## **Reindeer Project Construction Services, Savoonga** EDA Project Number 07 79 07873

### **Addendum #5** 7/19/2024

Summary of items included in this addendum:

1. (Updated) List of questions received during solicitation period and answers
  - pg. 2-4
2. (Updated) Architectural Sheet A-601
  - pg. 5
3. (Updated) Structural Sheets S-101, S-102, and S-501
  - pg. 6-8

**A-601**

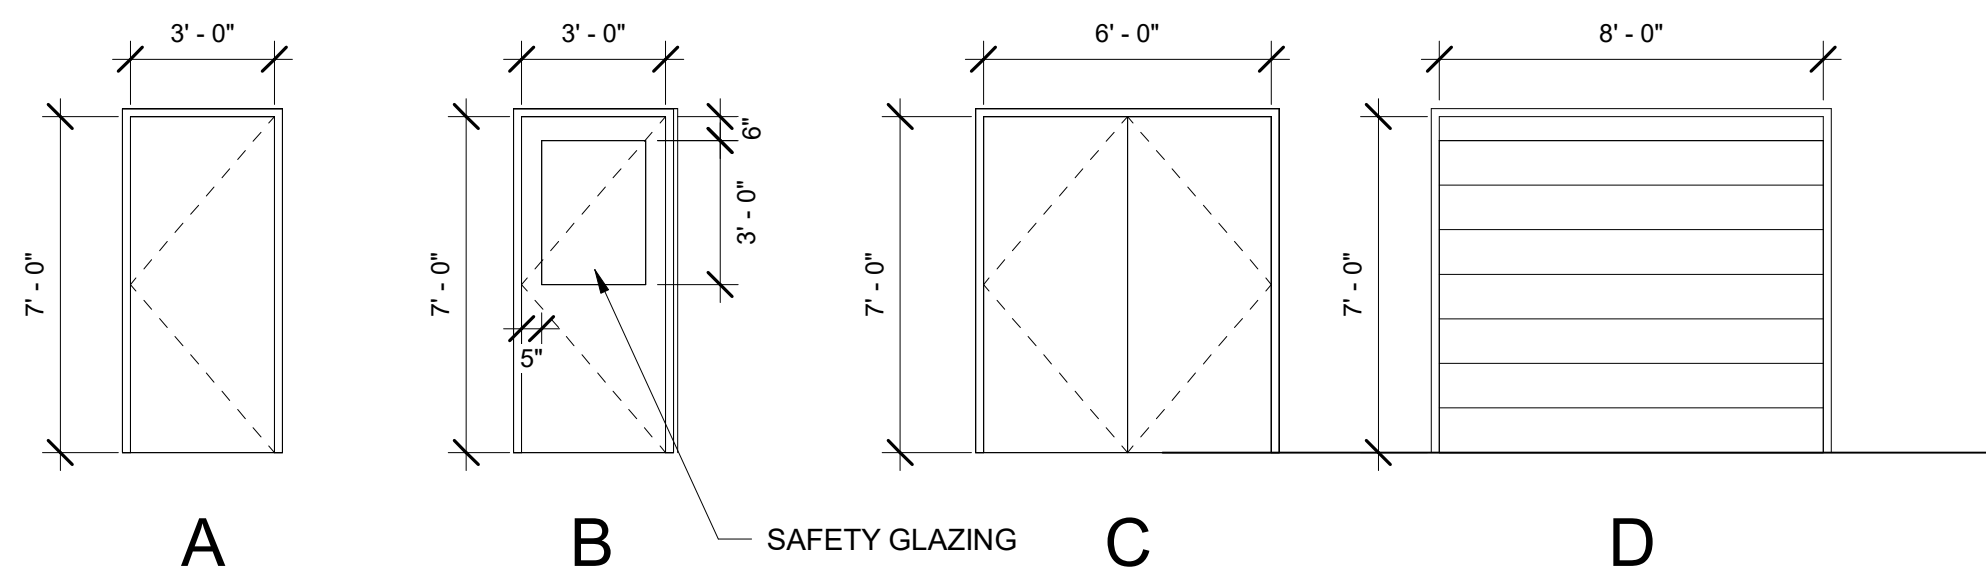
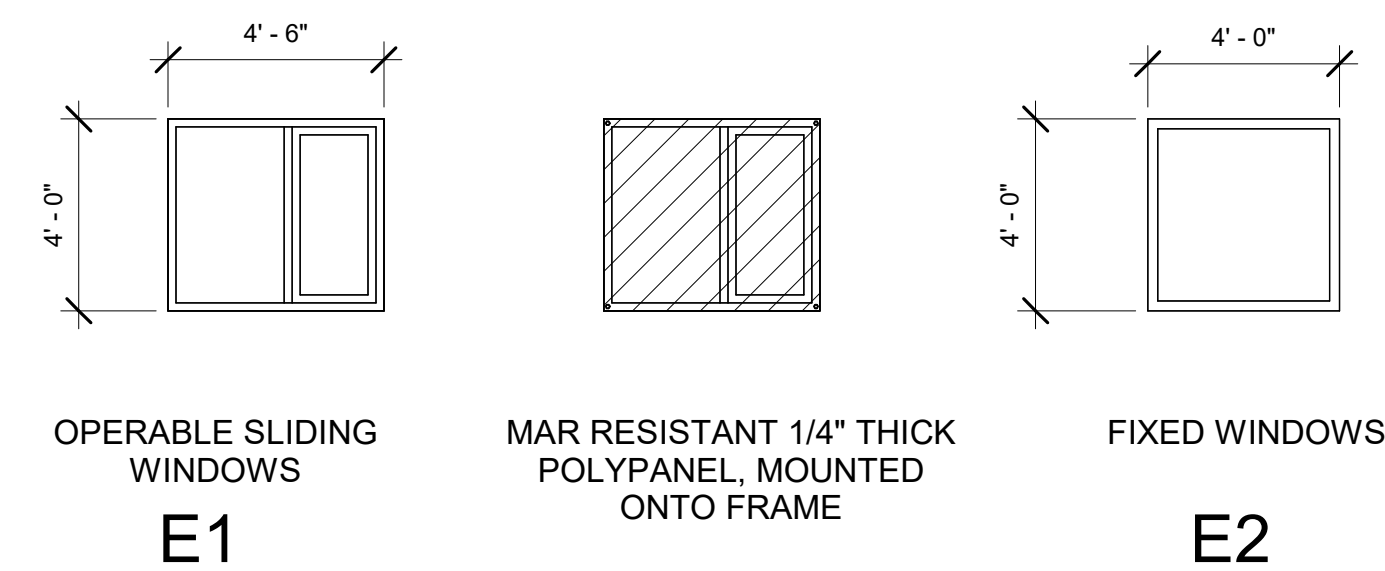
<u>Question Number</u>	<u>Question</u>	<u>Response</u>
1	Will you be issuing a schedule for section 087100 on this project?	Yes, the door and frame schedule is on sheet A601. Sheet A-601 has been revised to include clarifications to the room finish schedule and finish schedule abbreviations. The revised A-601 sheet is included in addendum #1.
2	Okay so what I did not see to be able to quote properly is the Hardware schedule for the doors and frames and if you will not have one then I would need the general idea below:	The hardware schedule is in the spec and should address your questions. Refer to Spec section 08 71 10 paragraph 3.8.
3	The bid document asks for a subcontractor in section 004113 - 2 for masonry work however, there is no work under this scope. Therefore, what masonry work is anticipated for this project?	Masonry work is not required as part of this project. Spec Section 00 41 13 has been updated and is included as part of addendum #1.

54	Please explain how the modules are designed to be lifted.	The file "2410_Lifting instructions.pdf" is included as part of addendum #3 to show better how the lifting is performed.
55	Please clarify the floor finish in the bathroom of the support building.	See revised sheet A-601, which is included in Addendum #5.
56	Are exterior stairs or ramps required at exterior door locations shown on the module facility floorplan?	<p>Yes, but only at the the exterior doors connected to rooms 401, 503, and 504. The GC shall include a total of 2 stair cases and 1 ramp in their estimate as part of base bid item 0004 (Installation of Processing Modules).</p> <p>1 stair case shall be out of rooms 401, another out of room 503, and a ramp out of Room 504. Stair cases shall be adjustable (to account for seasonal ground movement), and be International Building Code (IBC) compliant. Stair systems (prefabricated or constructed on site) to be set adjacent to exterior doorway identified on the approved modular facility plans. Stairs shall be constructed out of pressure treated wood or coated metal (aluminum or galvanized), grating shall match the support building stair system, stair and landings shall be supported by piles and have a minimum 5x5' landing at the top of the stairs/ramp. The minimum clear area for stair width shall be 48". Ramp shall be a minimum of 60" width and be compliant with IBC and ADA.</p> <p>Note, the staircases or ramp will not be attached to the module units, but will be "freestanding". Staircases, ramp and landings shall be rated for 1,000 lbs, riser height shall be 6", tread width shall be 12", with appropriate hand railings. Basis of design is Titan code compliant modular access system or approved equal.</p> <p>The GC shall submit shop drawings of staircase(s), pile locations, ramp, and sleepers (at base of stairs and ramp) including all fasteners, for approval prior to purchasing material. Provide finished floor elevation above finished gravel pad elevation with shop drawings. For estimating purposes, assume finish floor elevation of module facility is 30" above finished grade of the gravel pad.</p>

**S-101**

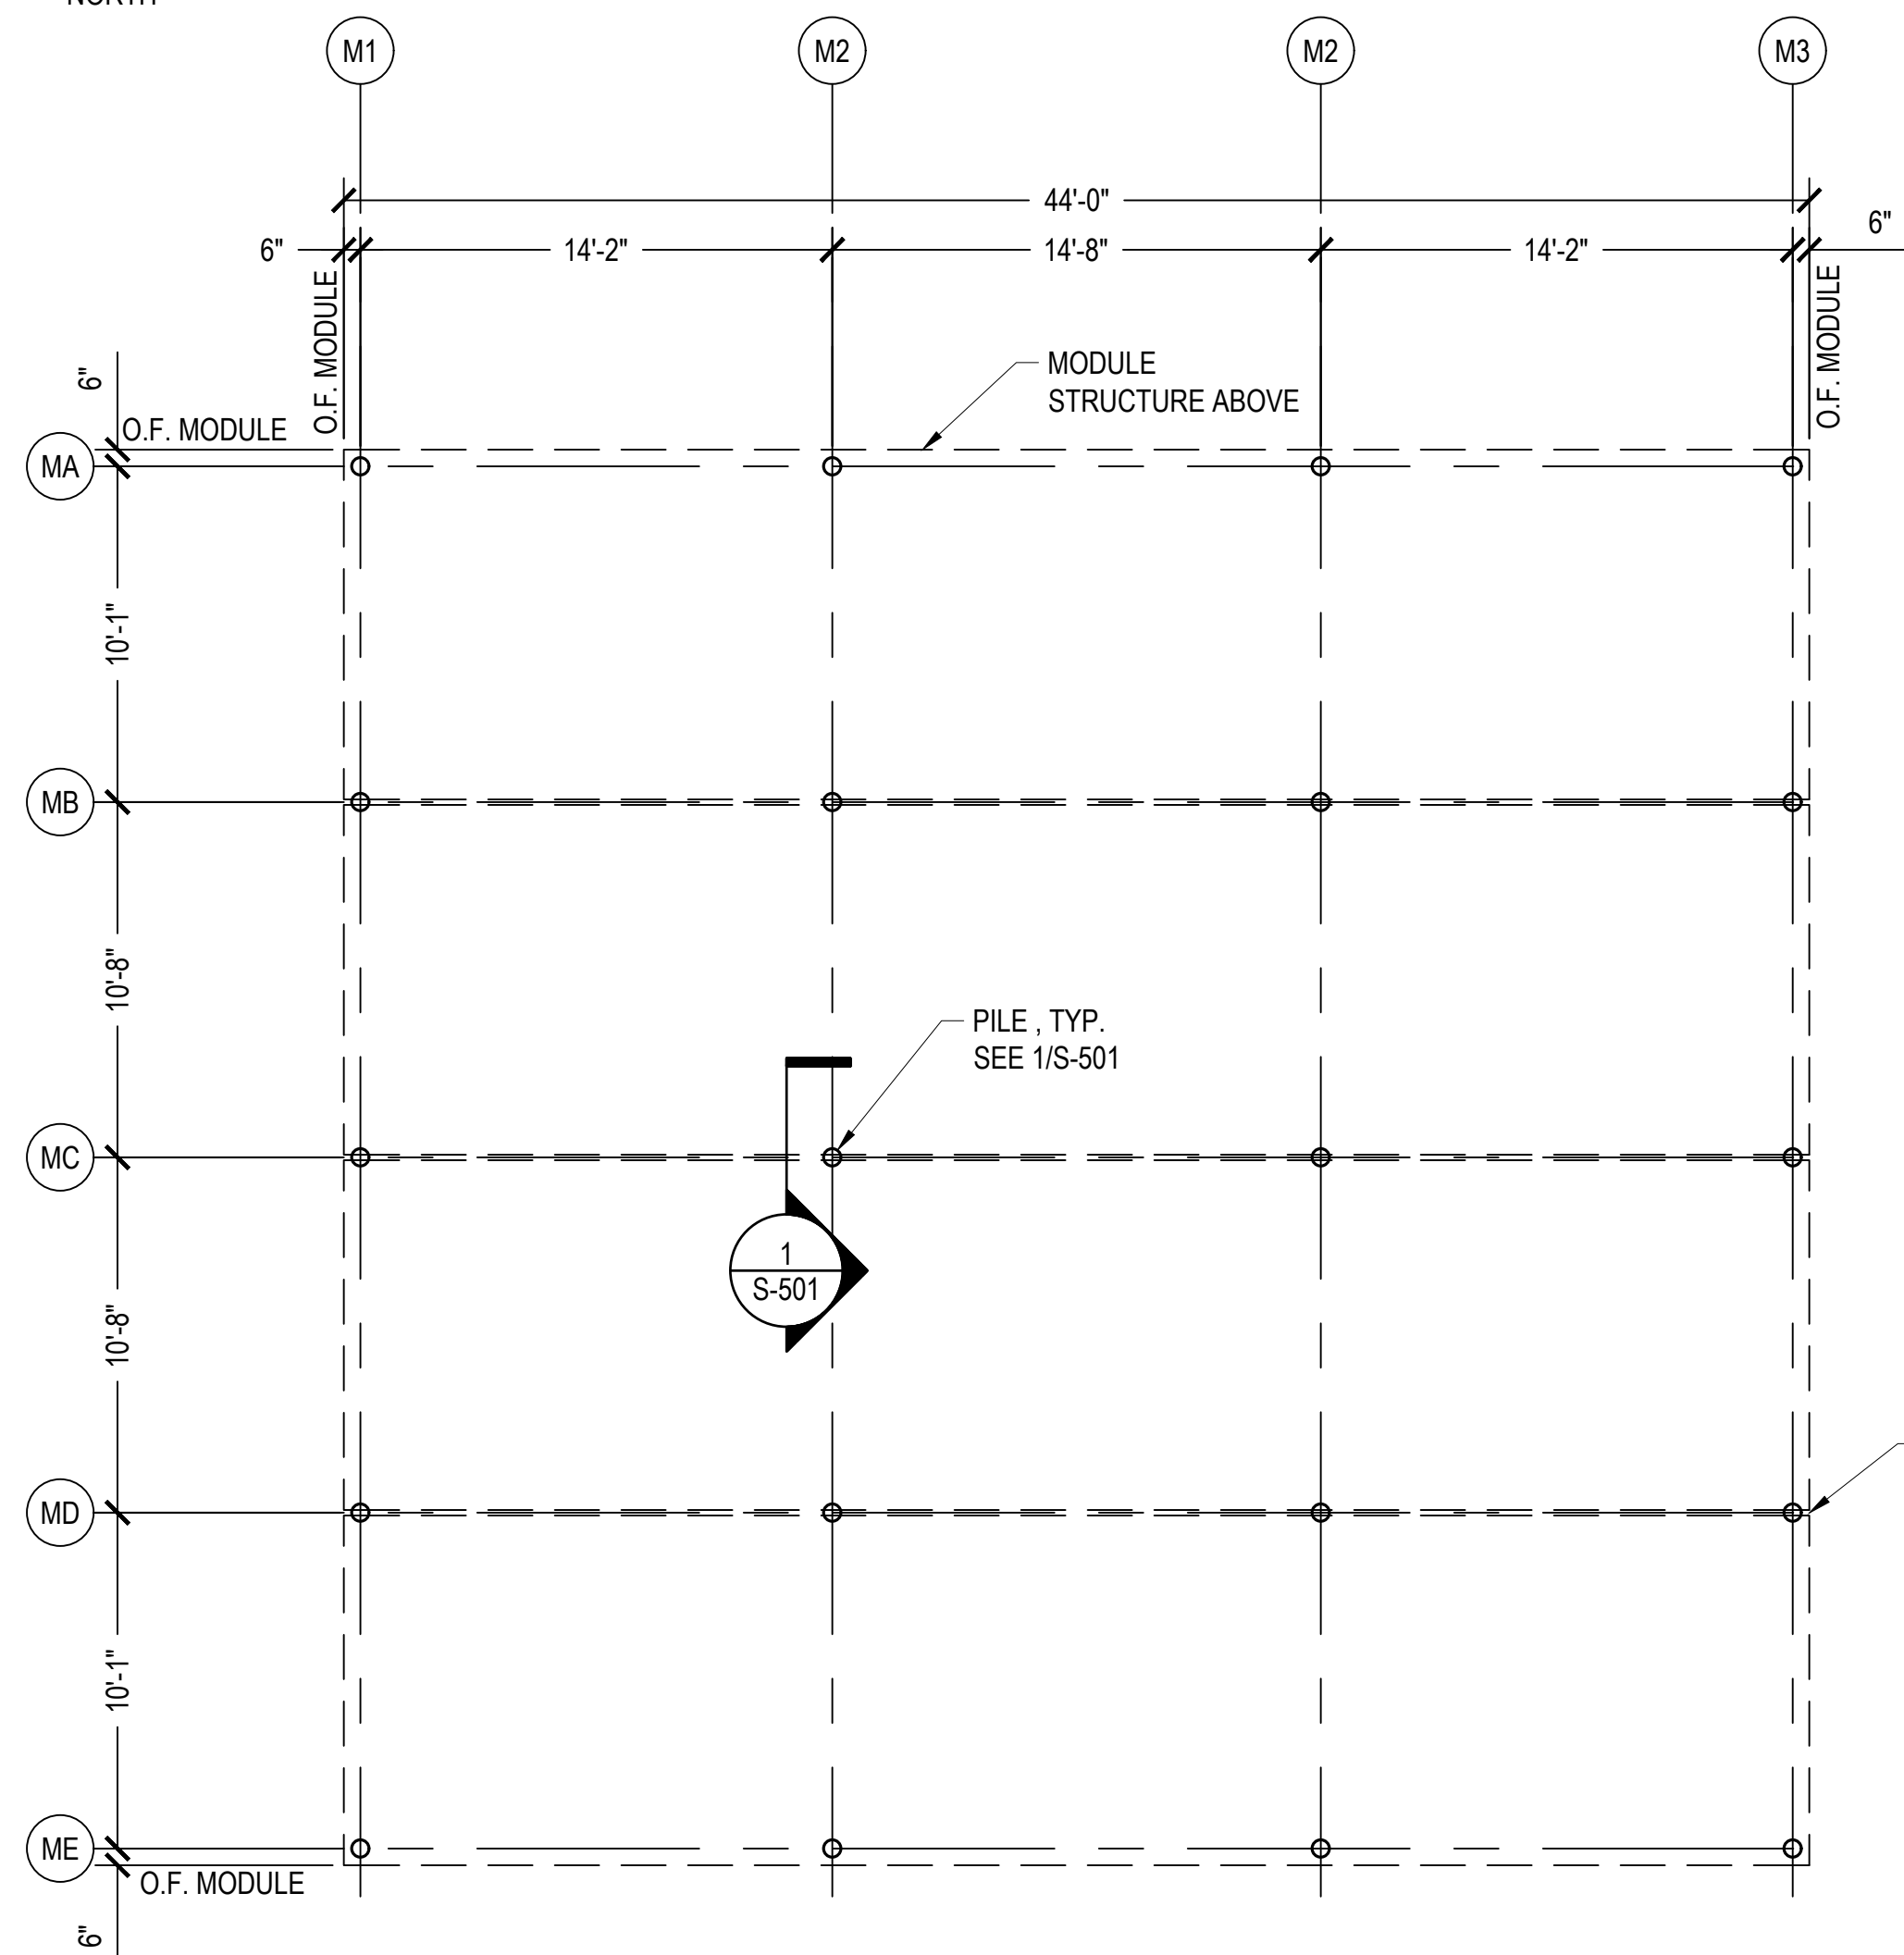
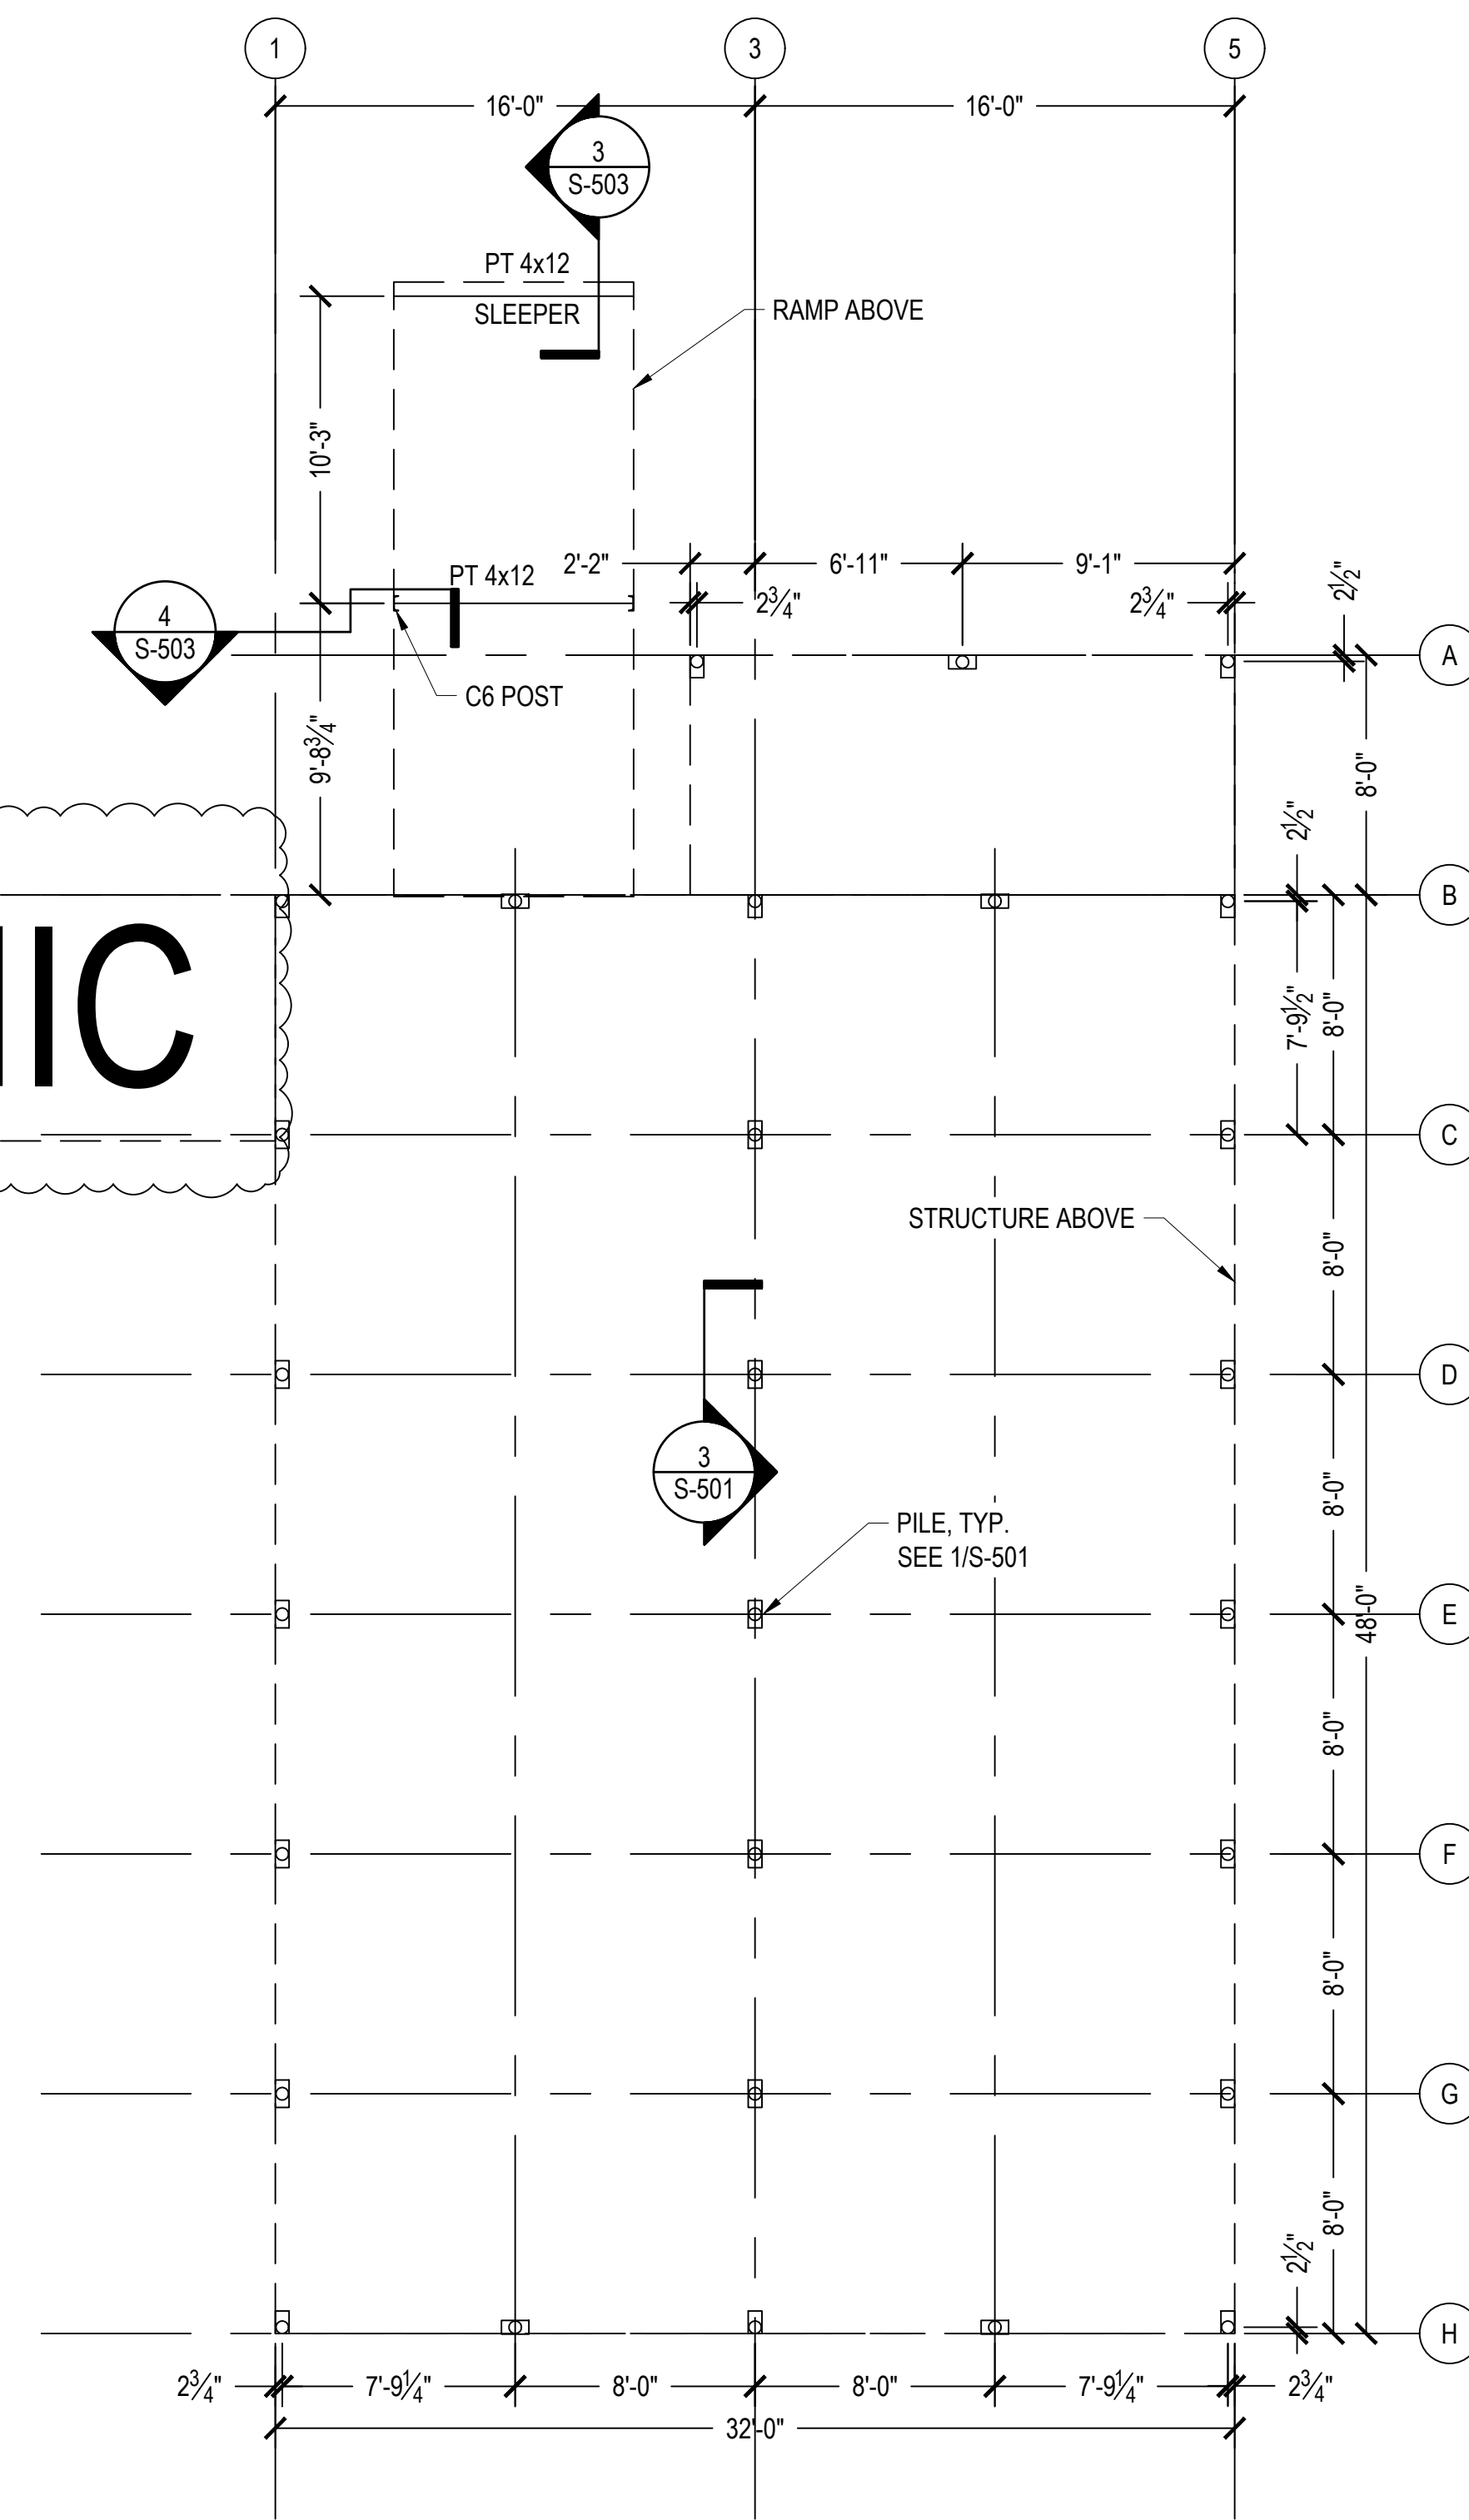
6	Please provide modular connection details. (Structural, roofing and siding details)	Refer to updated structural sheet(s), issued as part of addendum #5, for structural connection details. Refer to Exhibit A, issued as part of addendum #4, for General Contractor's involvement in roofing installation. Module exteriors are prefinished by the manufacturer and do not require siding to be installed.
7	Please confirm if the Water & Sewer Mains utilidor will be supplied and installed by others. See sheet C-200, detail 2	All water and sewer main utilidors shall be furnished and installed by the general contractor. C-200 has been updated to remove "by others" and is included in addendum #1.
8	On the Room Finish Schedule on A-601, please confirm that FRP panels are to be installed for the flooring in the bathroom.	Sheet A-601 has been revised to include clarifications to the room finish schedule and finish schedule abbreviations. The revised A-601 sheet is included in addendum #1.
